ADDENDUM NO. 1

Plans & Specifications for: Elsie Turner Field & Graverson Playground, Waltham, MA

In accordance with documents prepared by: Carolyn Cooney & Associates

DWG No. **L.201**

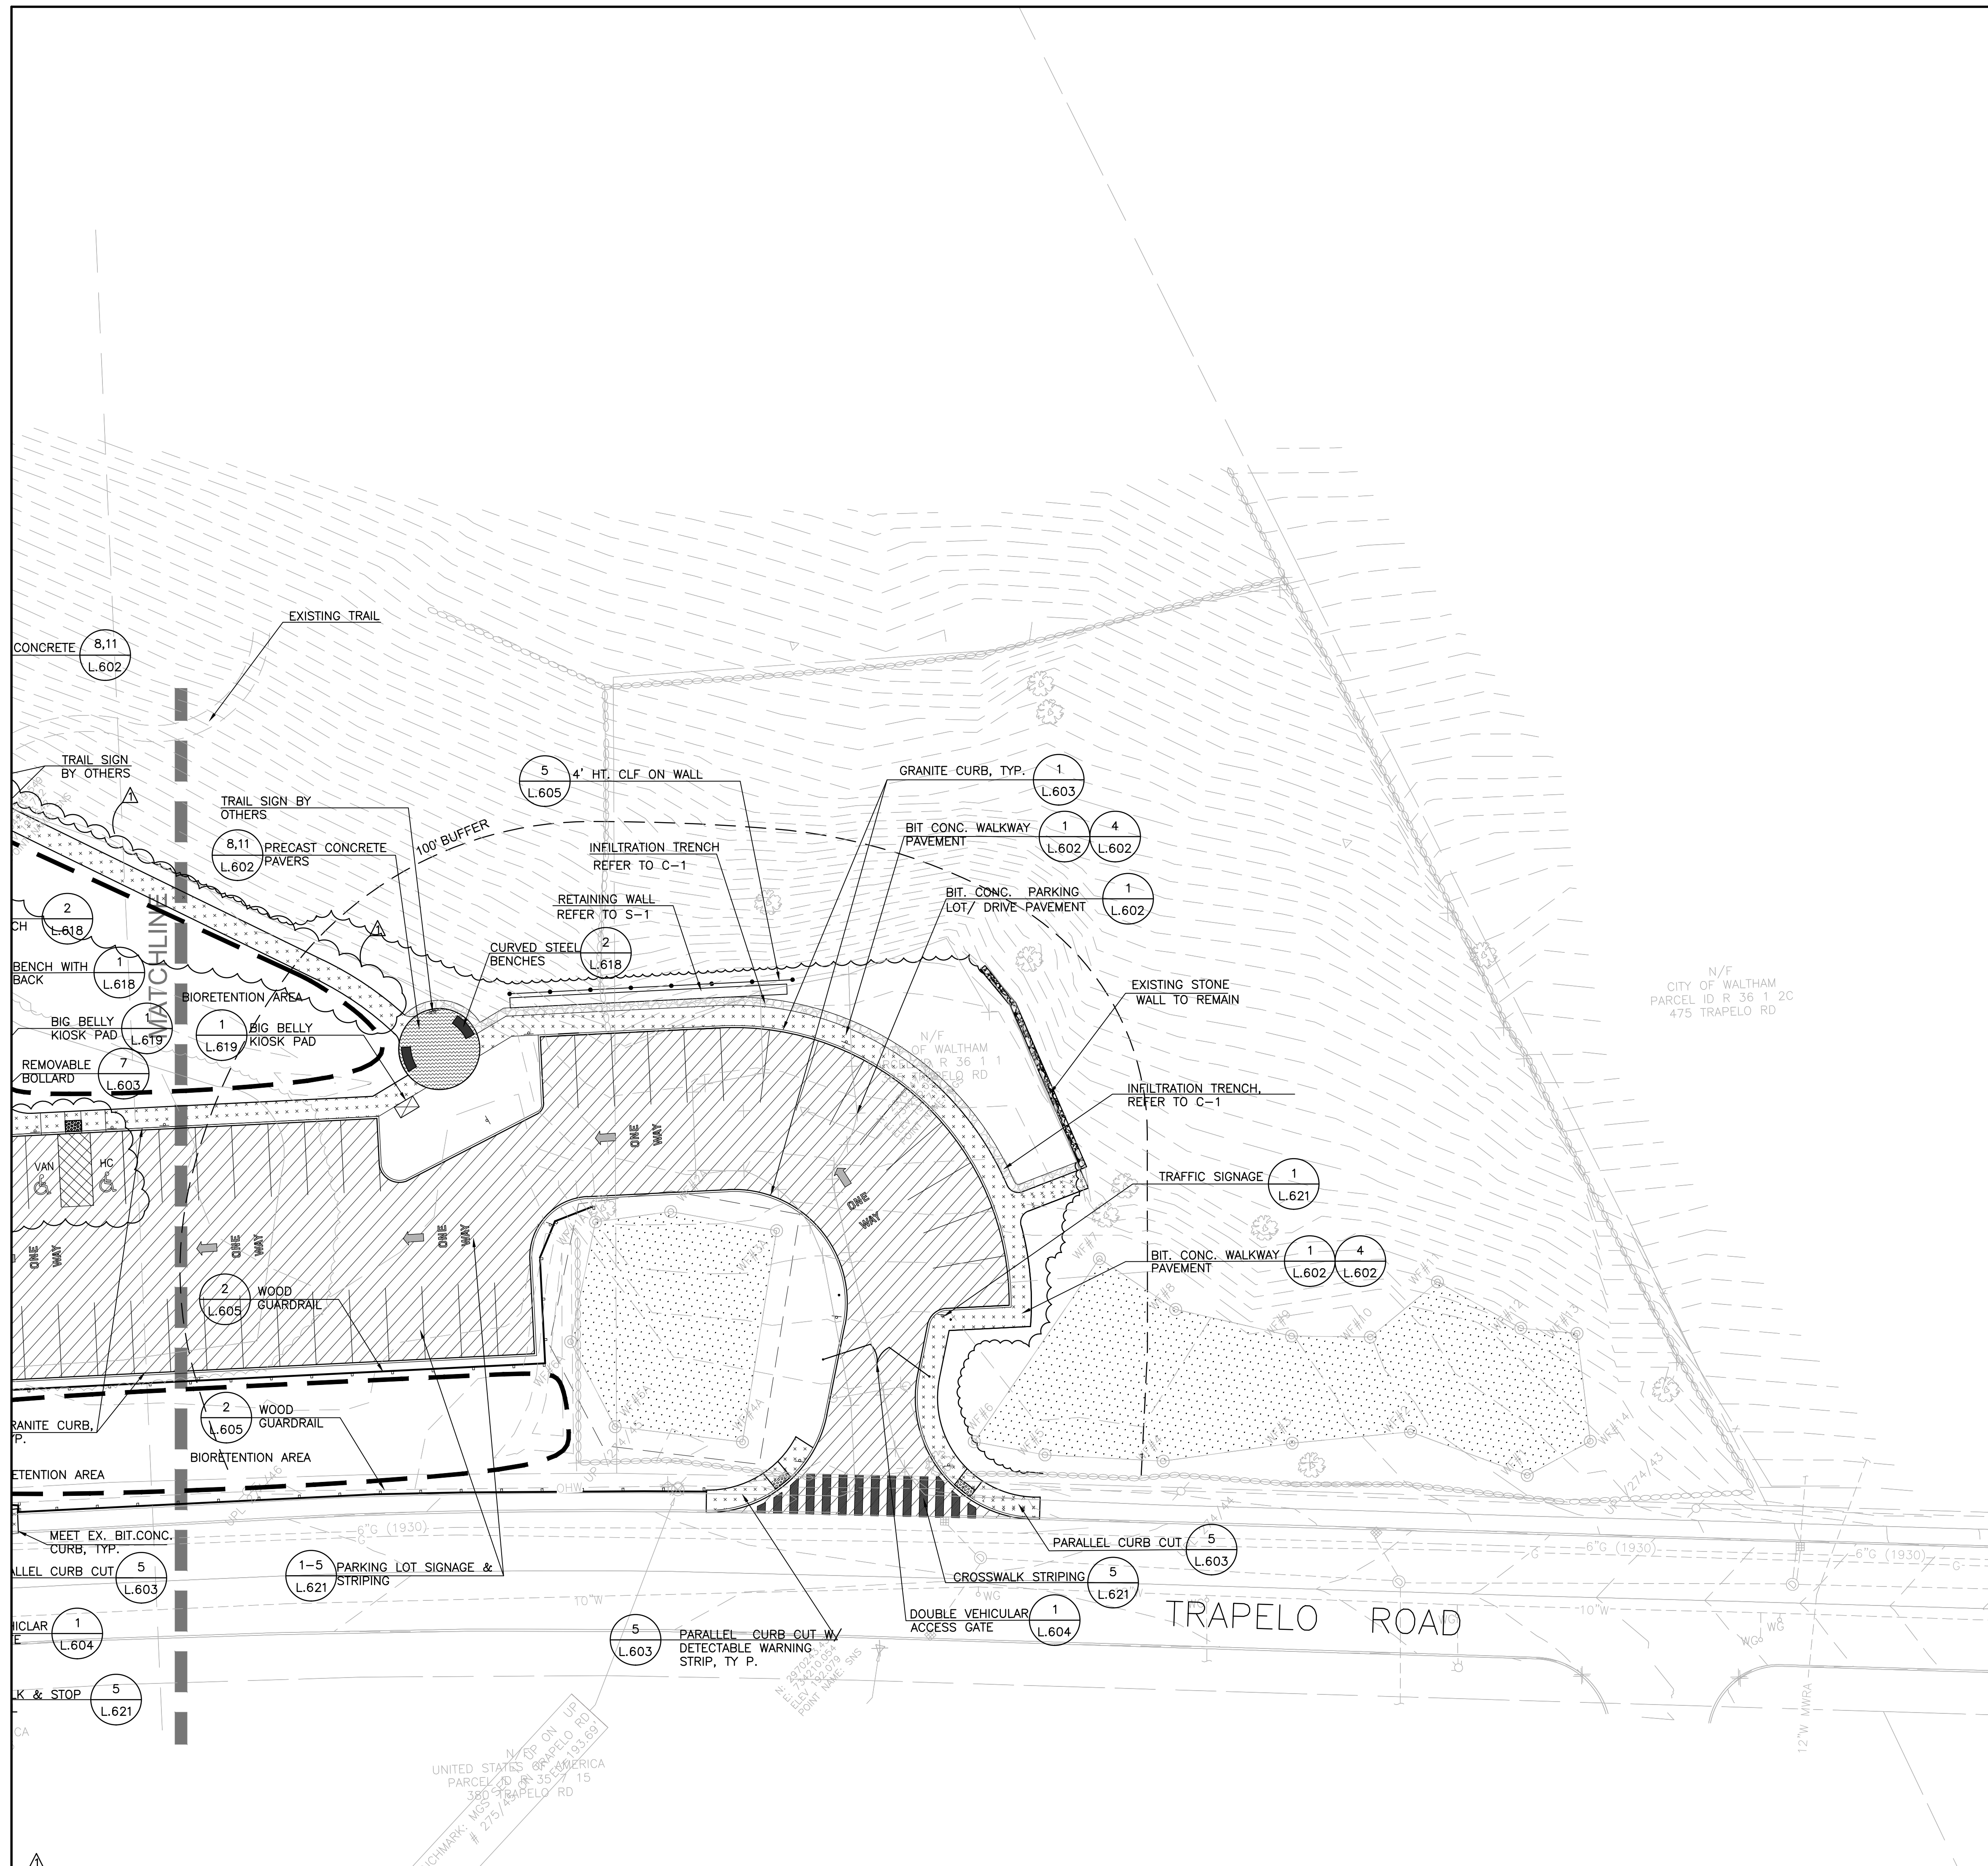
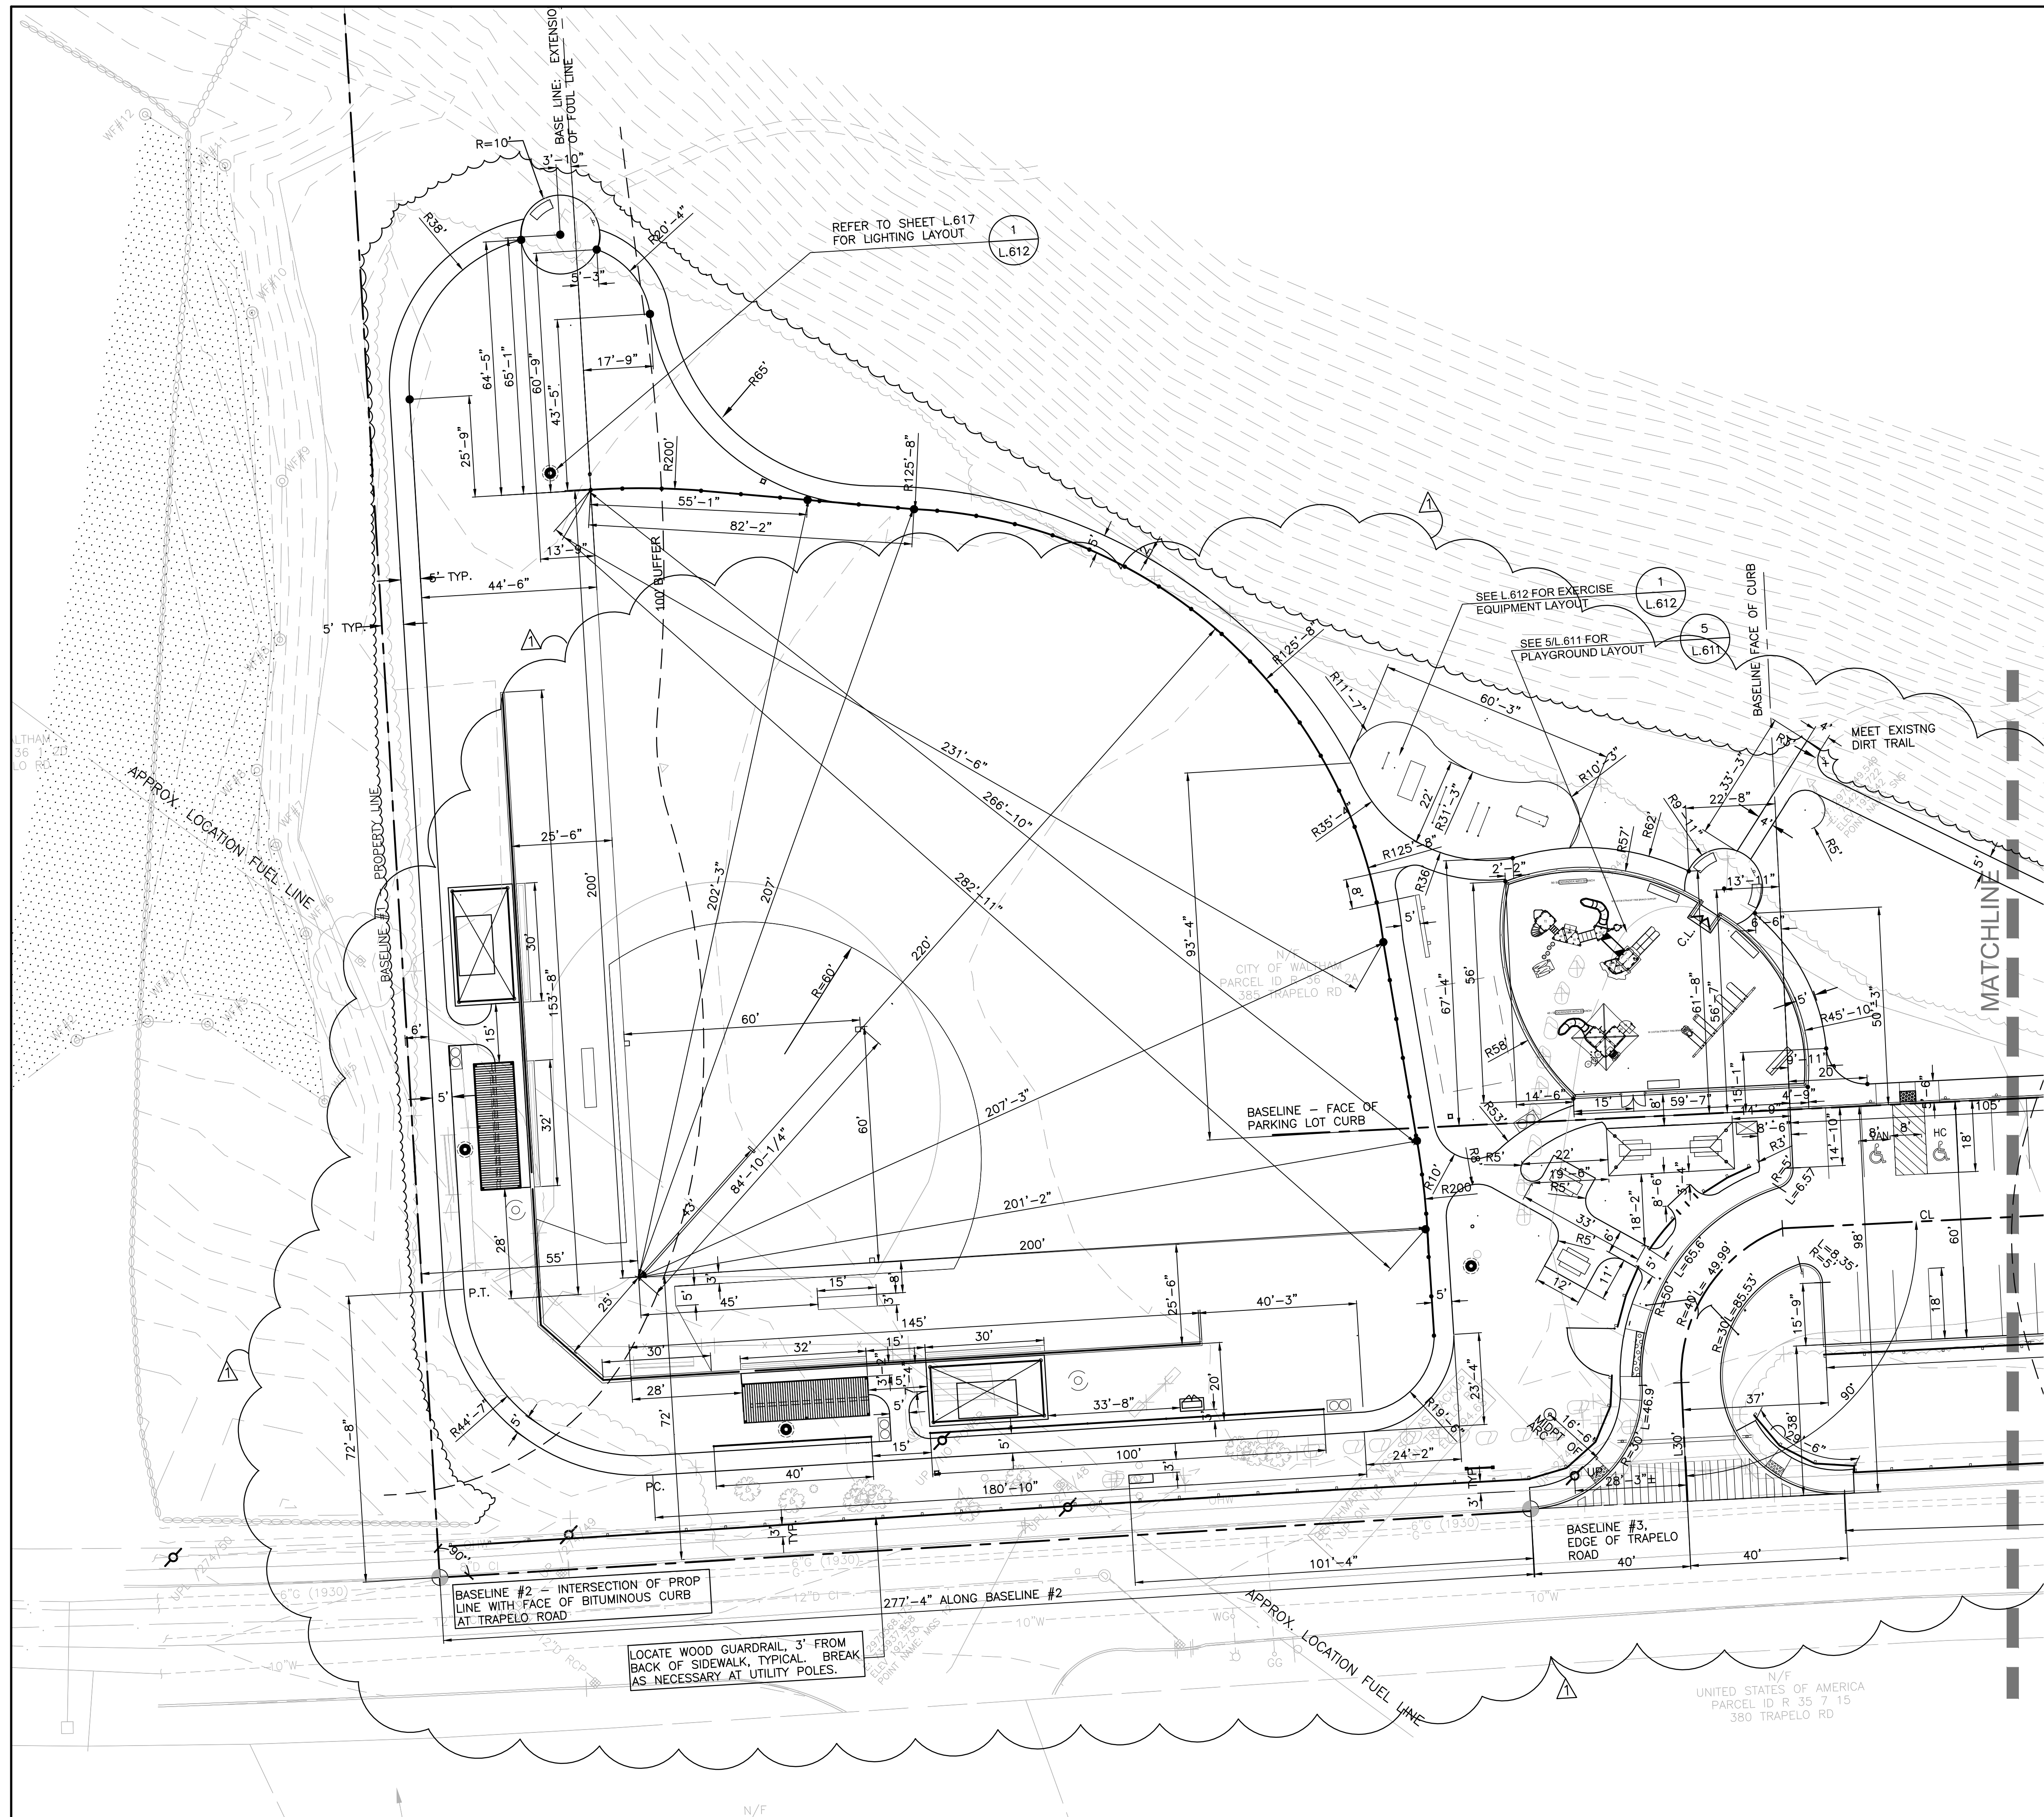
- ITEM NO. 14** *Elsie Turner Field: Replace Drawings L.201 and L.202 with new Drawings L.201 and L.202 attached. Revision includes repositioning of shade shelters at softball field, reduction in the amount of protective fencing, revision to size and shape of exercise area, revision to bioretention area 2 and surrounding walkway layout. Addition of trench drains and leaching basins at softball field.*
